**SERVICE BULLETIN 103 MANDATORY**

**SUBJECT:** NOSE GEAR OVER-CENTER SPRINGS

**APPLICATION:** All Glasair III aircraft that are ready for taxi testing or are already flying

FIGURE (1)

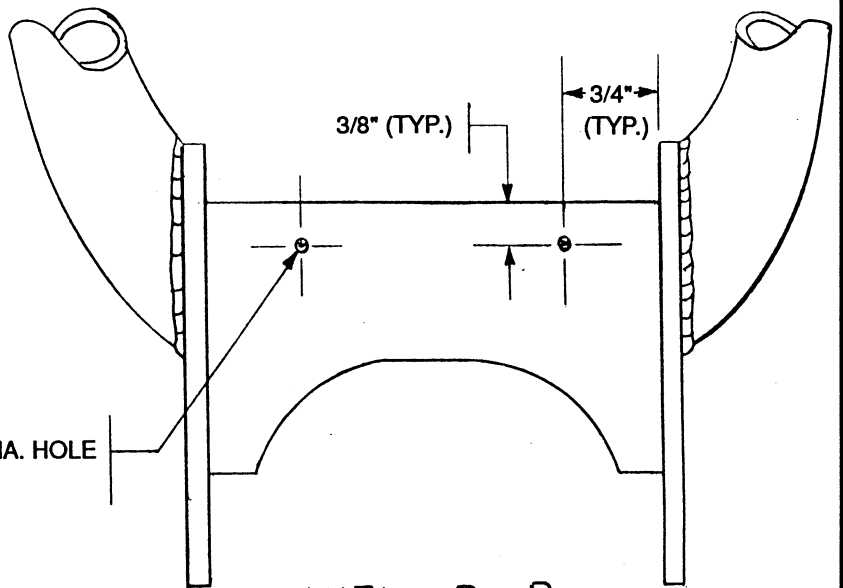
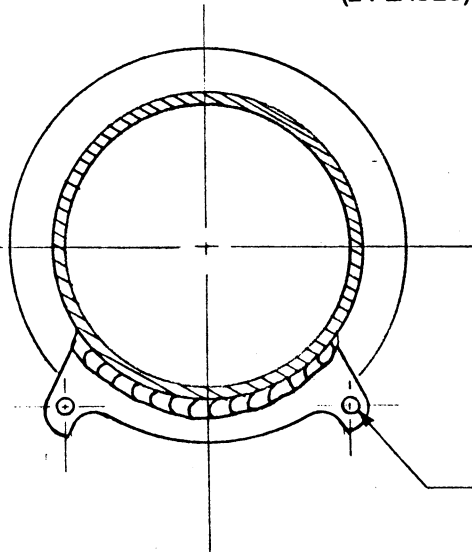
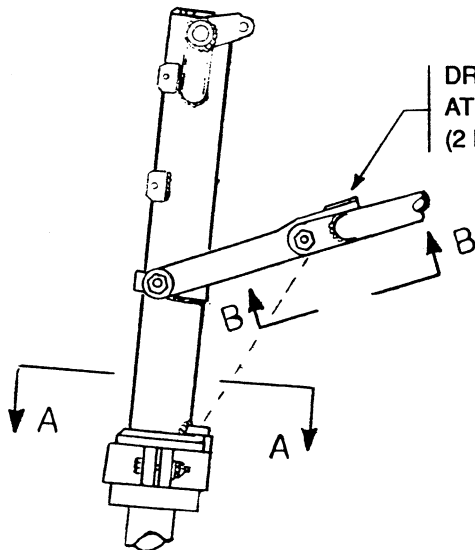
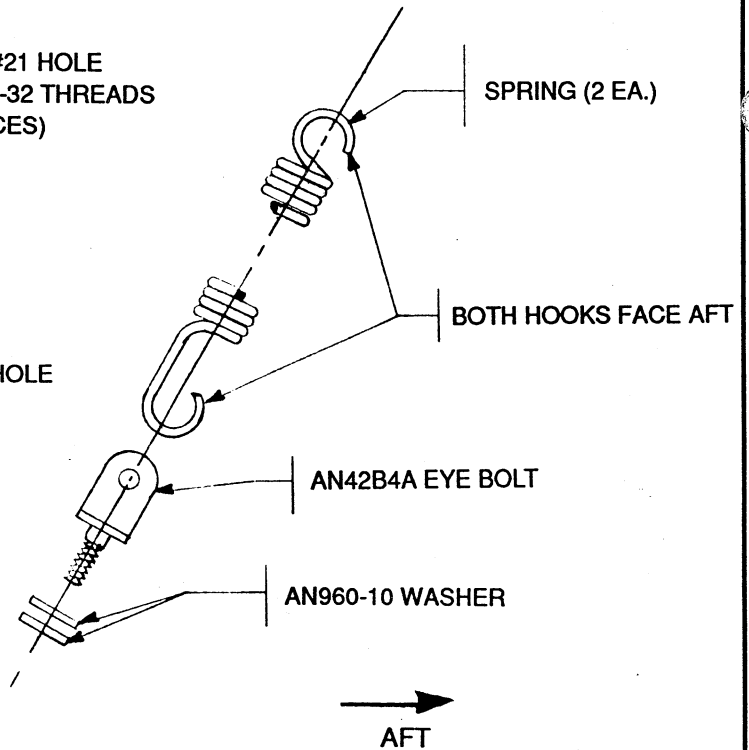
**DESCRIPTION:** We were recently informed of a Glasair III nose gear collapse that occurred when the hydraulic system failed to maintain adequate pressure in the gear extended position. Currently, emergency landing gear extension in the Glasair III is accomplished by means of a hydraulic hand pump, which is fairly typical of general aviation aircraft. Springs installed at the gear struts provide a backup for the hydraulic system by holding the main gear side braces and the nose gear drag brace in an overcenter position when the gear is extended. In the absence of hydraulic pressure, the present nose gear down lock spring may lack sufficient mechanical advantage to keep the drag brace assembly from folding when the nose gear is subjected to shimmy or rough terrain.

To assist the existing nose gear down lock spring, and to prevent the nose gear from collapsing if hydraulic pressure is lost, Stoddard-Hamilton Aircraft requires the installation of two nose gear over-center springs, as shown in FIGURE (1). The springs are to be installed between holes drilled in the curved plate at the forward end of the drag brace and eye bolts installed in the pivot stop plate on the nose gear strut.

Use a #21 drill bit to drill two holes in the nose gear pivot stop plate, which is part of the nose gear strut assembly, as shown in FIGURE (1). Drill parallel to the long axis of the oleo strut.

**NOTE:** Be careful when positioning the holes to provide clearance from the strut body for the 10-32 tap that will be used to cut the threads. If the tap contacts the strut body underneath the stop plate, it can break the tap.

Tap the holes with a 10-32 tap. Thread an AN42B4A eye bolt into each hole with two AN960-10 washers stacked under the shoulder of each bolt. Secure the eye bolts with Loc-tite thread lock adhesive.

Drill two 1/8" diameter holes in the curved plate at the forward end of the drag brace, as shown in FIGURE (1). Drill the holes at an angle to align with the axes of the installed springs.

Install the over-center springs, as shown, with the hooks at both ends oriented AFT. (The hook at the eye bolt end must face aft to allow the spring to clear the uplock actuating arm shaft when the gear is retracted; the hook at the drag brace end must face aft so that it does not tend to rotate out of the hole during gear operation.)

DRILL 1/8" DIA. HOLE  
(2 PLACES)

DRILL #21 HOLE  
TAP 10-32 THREADS  
(2 PLACES)
